UNITED STATES
NUCLEAR REGULATORY COMMISSION
WASHINGTON, D.C. 20555-0001

SUBJECT: PALISADES NUCLEAR PLANT- STAFF ASSESSMENT OF INFORMATION PROVIDED PURSUANT TO TITLE 10 OF THE *CODE OF FEDERAL REGULATIONS* PART 50, SECTION 50.54(f), SEISMIC HAZARD REEVALUATIONS RELATING TO RECOMMENDATION 2.1 OF THE NEAR-TERM TASK FORCE REVIEW OF INSIGHTS FROM THE FUKUSHIMA DAI-ICHI ACCIDENT (TAC NO. MF3786)

STAFF ASSESSMENT BY THE OFFICE OF NUCLEAR REACTOR REGULATION

PALISADES NUCLEAR PLANT

Figure 3.3- 1 Plot Comparing the Staff's and the Licensee's Median Amplification Functions and Uncertainties for the Palisades site.

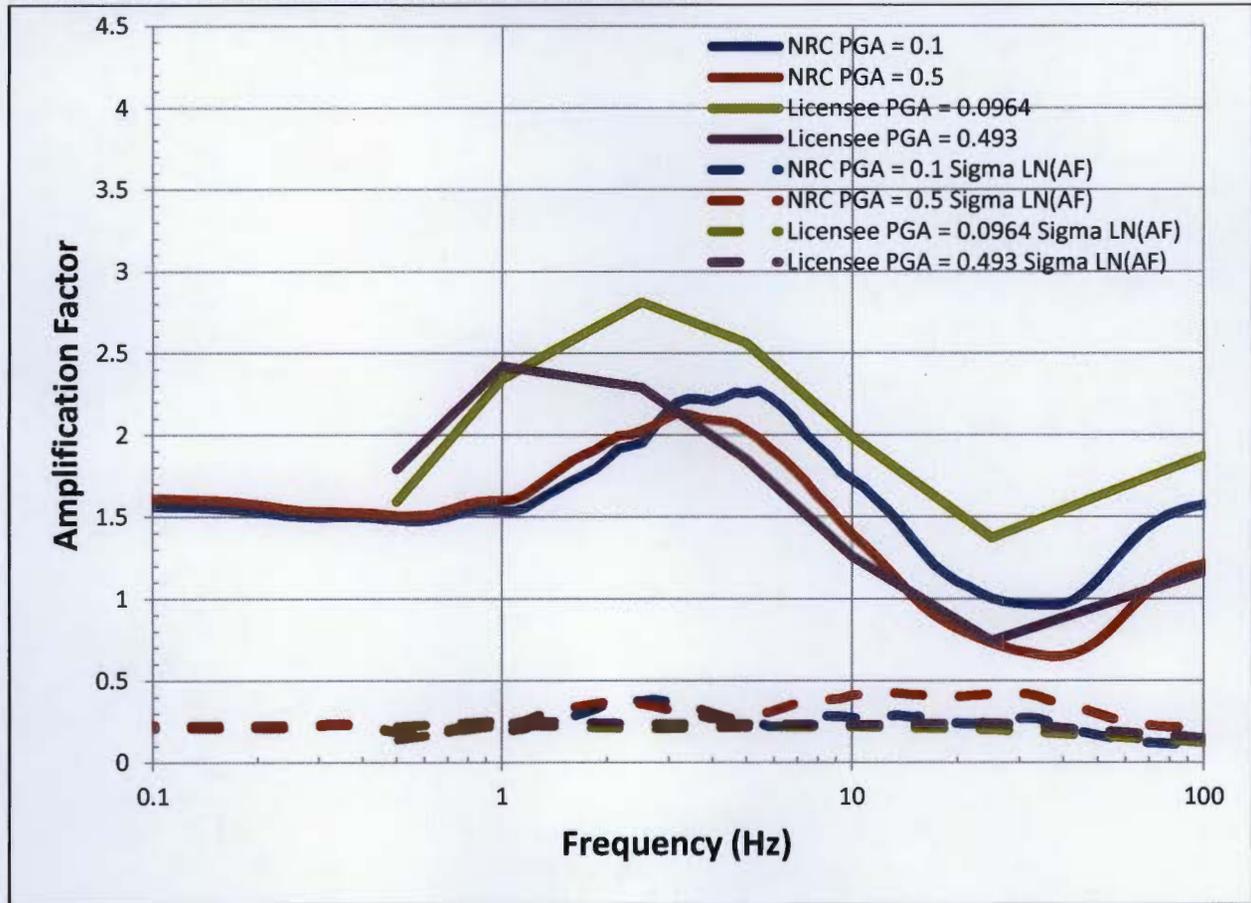
Figure 3.3-2 of this assessment shows a comparison on the staff's and the licensee's median site amplification functions and associated uncertainties (± 1 standard deviation) for two of the eleven input loading levels. Peaks in amplification functions occur between approximately 1 and 5 Hz in

both staff and licensee curves. Differences in the amplification functions developed by the staff and licensee are due to the licensee's use of six profiles, as described above, with three of the six profiles having reference rock directly beneath the soil layers.

The licensee's approach to modeling the subsurface rock properties and their uncertainty results in higher amplification factors at low and high frequencies compared to those developed by the staff. As shown in Figure 3.3-3 of this assessment, these differences in site response analysis have a moderate impact on the control point seismic hazard curves and the resulting GMRS as discussed below. Specifically, hazard curves developed by the licensee are higher than those developed by the staff at 1.0 Hz, but consistent at other frequencies. These differences are the result of differences in site response analysis. Appendix B of the SPID provides guidance for performing site response analyses, including capturing the uncertainty for sites with less subsurface data; however, the guidance is neither entirely prescriptive nor comprehensive. As such, alternative approaches in performing site response analyses, including the modeling of uncertainty, are acceptable for this application.
